Homebush Station Upgrade

Determination Report

Homebush Station Upgrade Determination Report

Figure 2: Key elements of the revised Proposed Activity

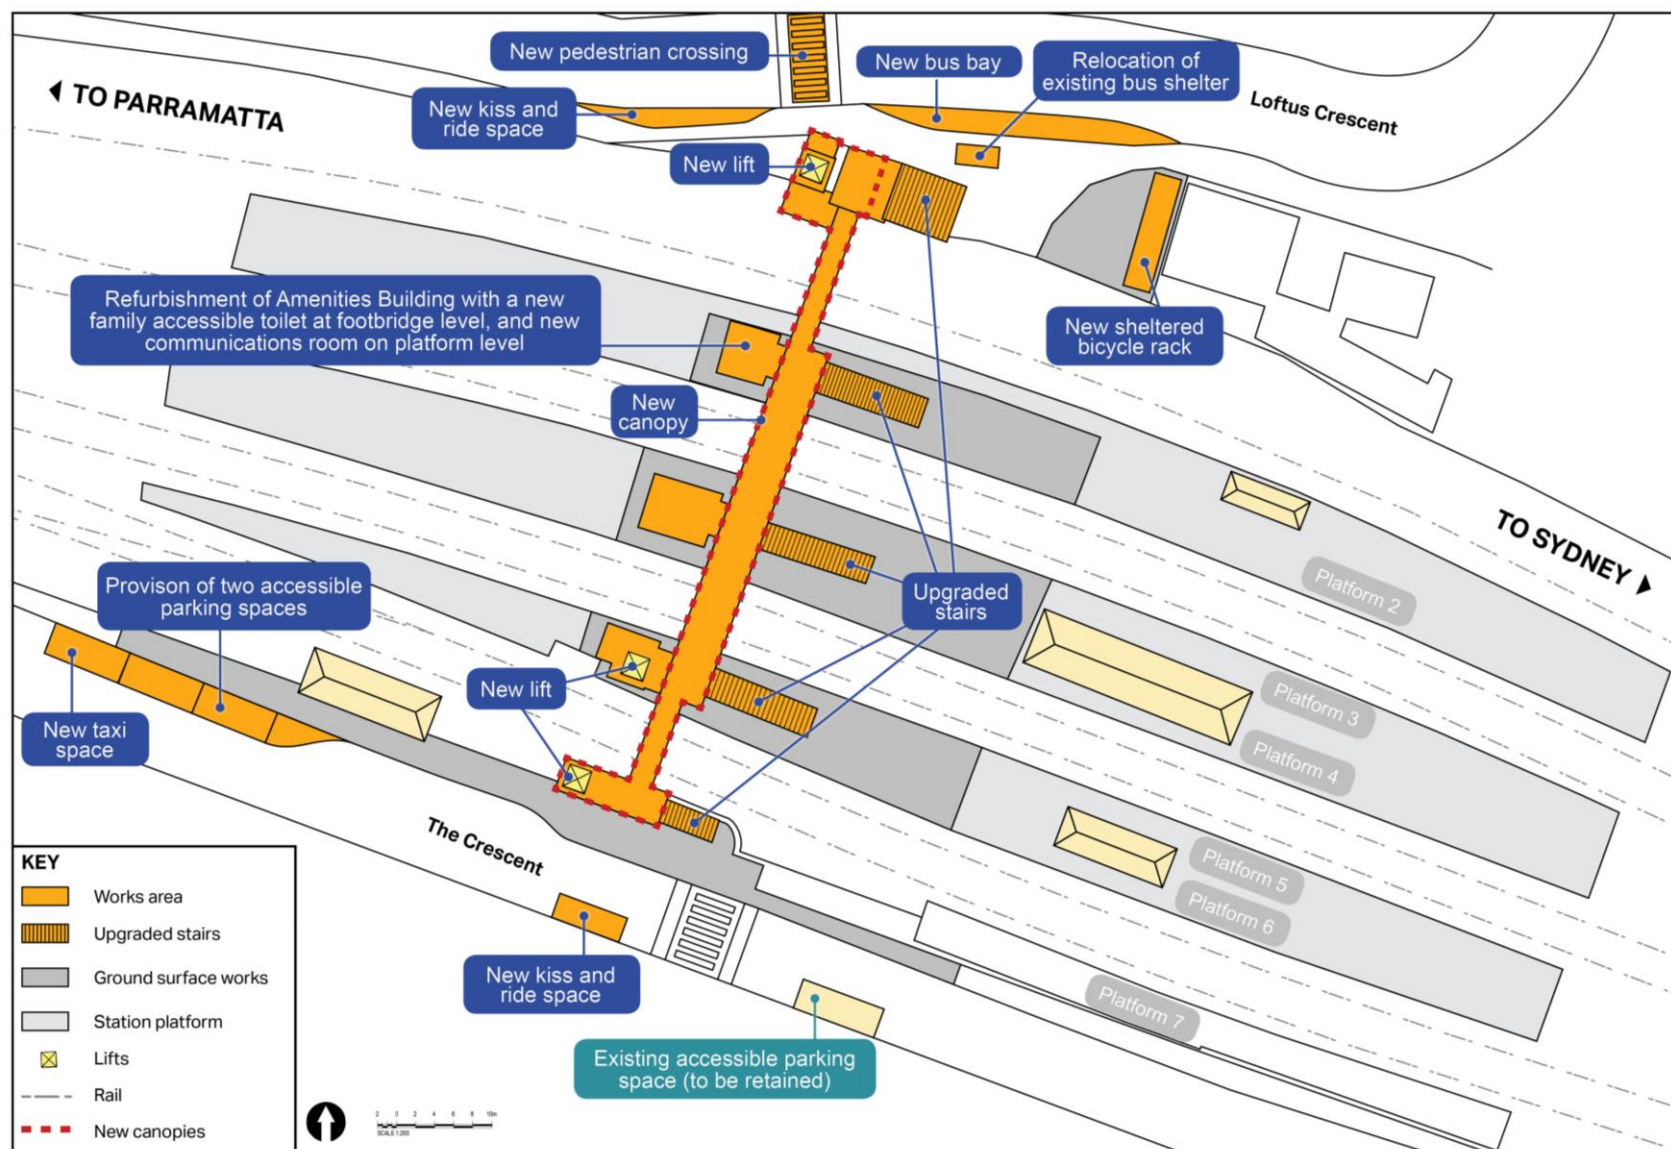
As a result of feedback and conditions issued by the NSW Heritage Division (refer to Appendix C) and additional investigations on how to best provide value for money and improve access; a change in scope has been proposed. The key changes include:

- relocating the communications room from the Booking Office at platform level on Platform 3/4 to the Amenities Building at platform level on Platform 1/2
- removal of the proposed lift and associated lift landing canopy from Platform 3/4 and retention of the existing station office at footbridge level.

- installation of three new lifts and upgrades to existing station access stairs to provide access to the existing footbridge and Platform 5/6
- installation of new canopies along the existing footbridge and lift landings for weather protection

- upgrades to the northern and southern station entrances
- refurbishment of the Amenities Building with a new family accessible toilet at footbridge level and new communications room at platform level
